51-53 HATTON GARDEN

REAR YARD REVISION

13551-51-53 HATTON GARDEN — SECTION 73: REAR YARD REVISION

PROPOSED: SCHME LGF

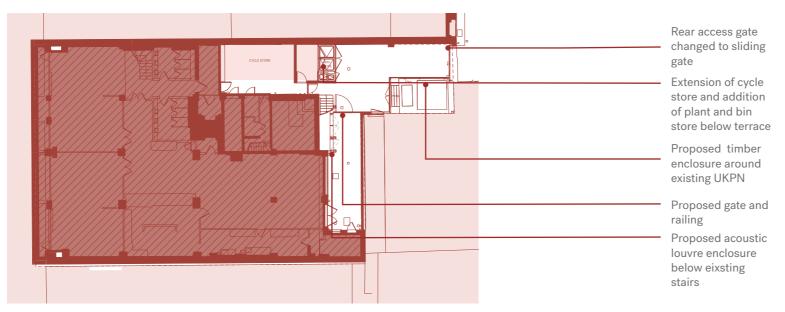
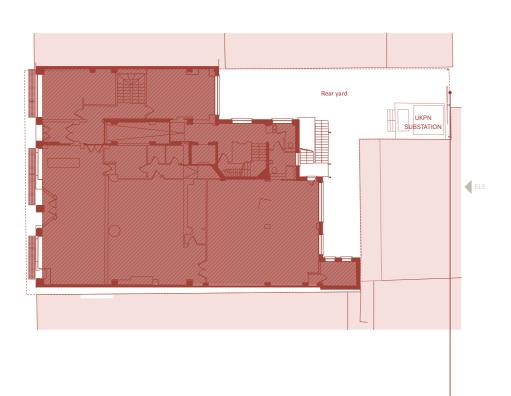
In the consented scheme the ground floor terrace had two entrances with two new openings to access the space and a staircase leading down the the lower ground rear yard.

The new aspiration is to partially reduce the L00 terrace and remove the staircase. The binstore is located on the end enclosed with black painted louvres and plant space is moved next to the bin store. We are still retaining amenity space and planting on L00 terrace as in the consented scheme.

There will also be black painted metal gate and railings enclosing the lower ground floor terrace accessed off the office as well as a new louvred enclosure for plant equipment under the existing staircase.

In addition, a new timber cladding is proposed to enclose the existing UKPN substation.

2.0 SUMMARY OF PROPOSED ALTERATIONS: ROOF PLAN

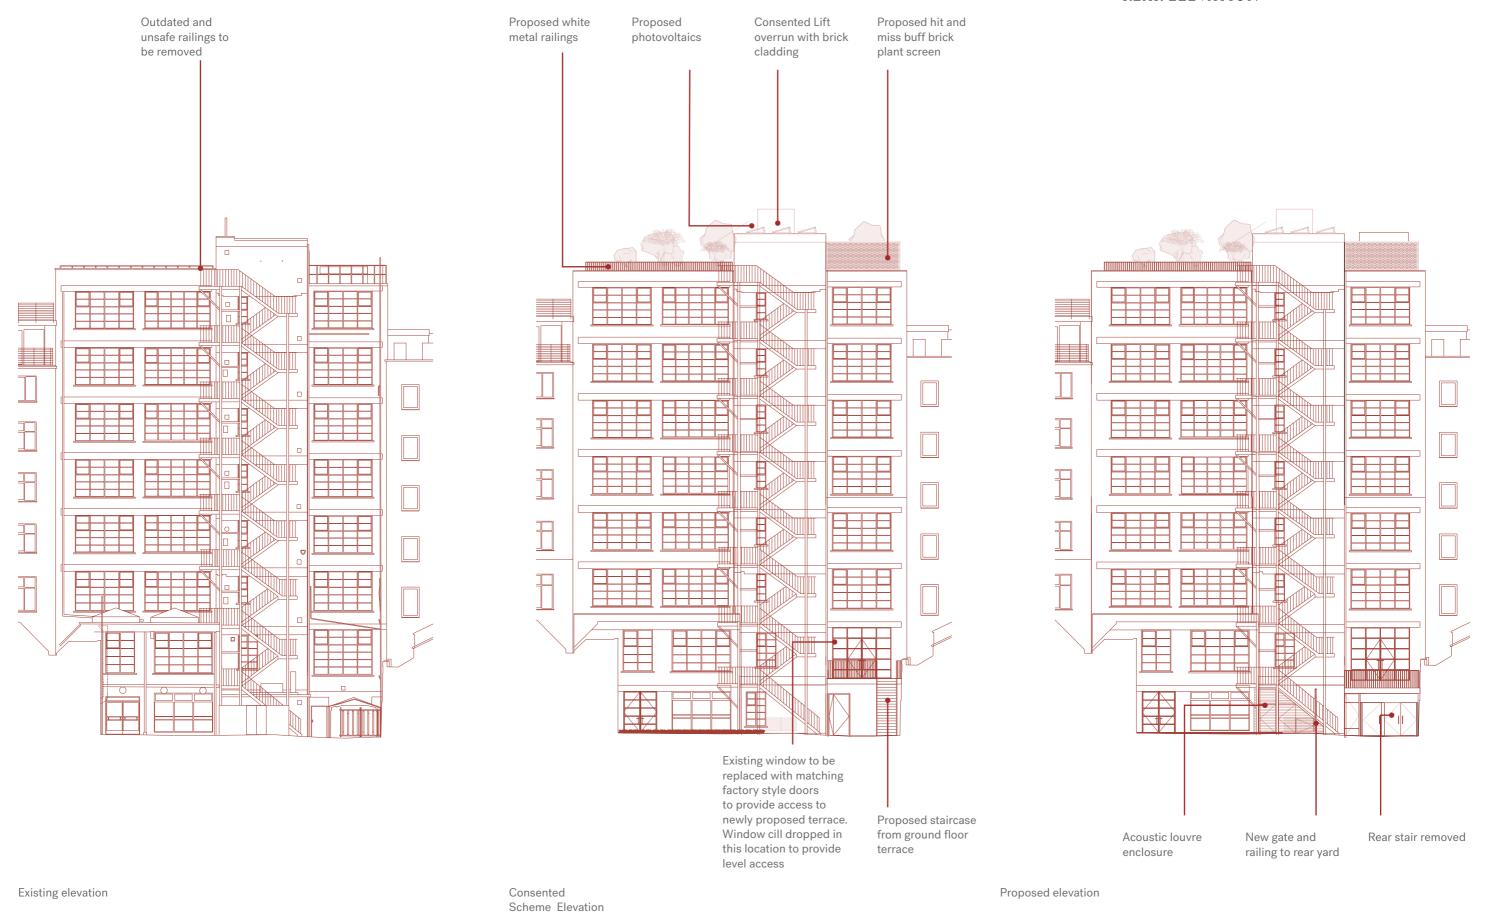
Outdated rear access gate to be removed

Reduced rear terrace and removal of staircase

New gate and railing

Timber louvre to existing UKPN substation enclosure

Rear access gate changed to sliding gate

2.1 SUMMARY OF PROPOSED ALTERATIONS: REAR ELEVATION

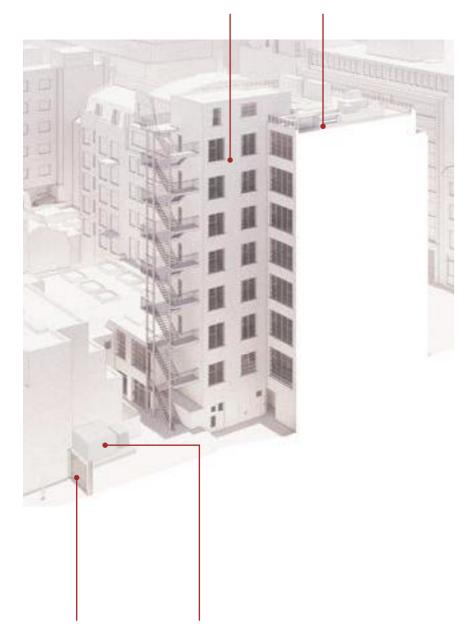
Roof plant equipment to be removed

Outdated and unsafe railings to be removed

Outdated rear access gate to be removed

New rear access gate

Rear access gate changed to sliding

Existing UKPN substation to be enclosed by timber cladding

Proposed Axo

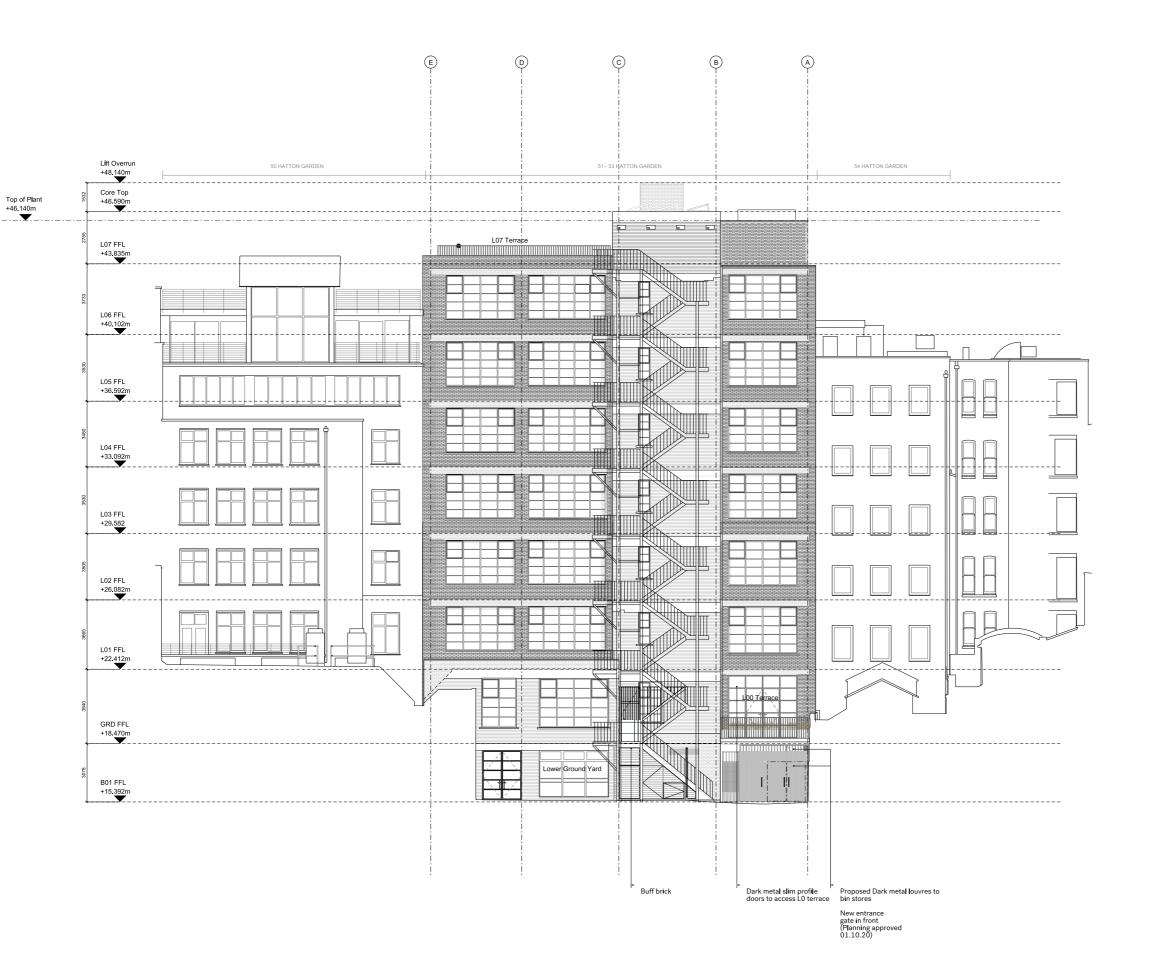
Relocation of bin store to front end of terrace

Terrace end pulled back and stair to rear court removed
